CASE: PA629073
EXHIBIT: Site Plan
DATE: 11-16-2023
PLANNER: A. Oquendo

PROJECT:	MERVYN FLORY RV PARK
DATE:	NOV 8 2022
SCALE:	1" = 20'
DRAWN BY:	D.M.
CHECKED:	D.M.
SHEET:	E2

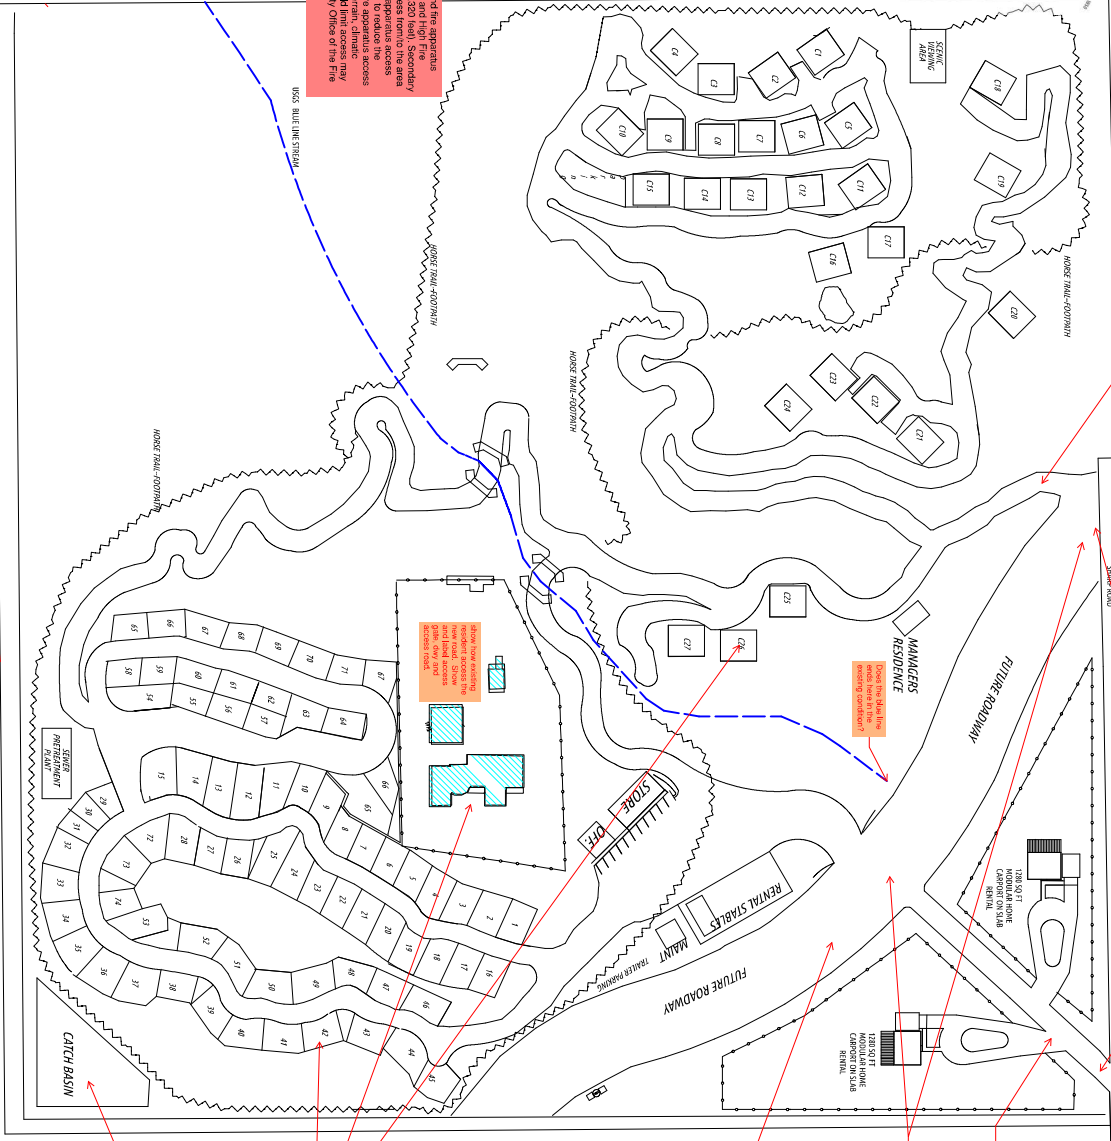
Secondary Access: Unless otherwise approved by the Fire Department and the appropriate Hazard Severity Zone area, 800 level or Moderate Fire Hazard Severity Zone, 1,320 level. Secondary access routes for apartment access roads shall provide independent egress/access from the area. Secondary access routes shall be as remote as possible from the primary fire apparatus access road to reduce the possibility that both routes will be obstructed by a single emergency. Additional fire apparatus access conditions, associated magnitude of a potential incident, or other factors that could limit access may be required by the Fire Department. Reference CFC 503.1.2 and Riverside County Office of the Fire Marshal Normal Policy #1725202.

Coordinate with CUP-180014 for appropriate siting the project's solar boundary.

Provide typical section of internal roads. Indicate public or private?

Typical comment: all centerlines to intersect at 90 degrees.

Indicate how existing sewer, storm, and lead access lines will be reconnected to existing lines.

Does this site have existing conditions?

Provide interim improvements to be provided on the internal roads.

Provide ROW and improvements on Stamp Road of all between the posted and the existing County maintained portion of Stamp Road per SDC 90. Section 90.50.40.45.11.

Provide an alignment study for road between Spring Street and Della Street. All streets will be reconfigured to allow centerlines to intersect at 90 degrees. Provide full width ROW decision within the site per SDC, Sec. Ord. 4611.11.

Provide a traffic study and WMT analysis. Provide more details on the operations. Provide a grading and drainage exhibit.

Label uses.

Provide a Storm Area VADP Applicability Checklist. Provide a hydrology report.

Locate the existing lowest elevation point and determine if the proposed corner of the lot meets the existing low point of the project site.

Provide 30' ROW boundary. Provide 30' ROW boundary.
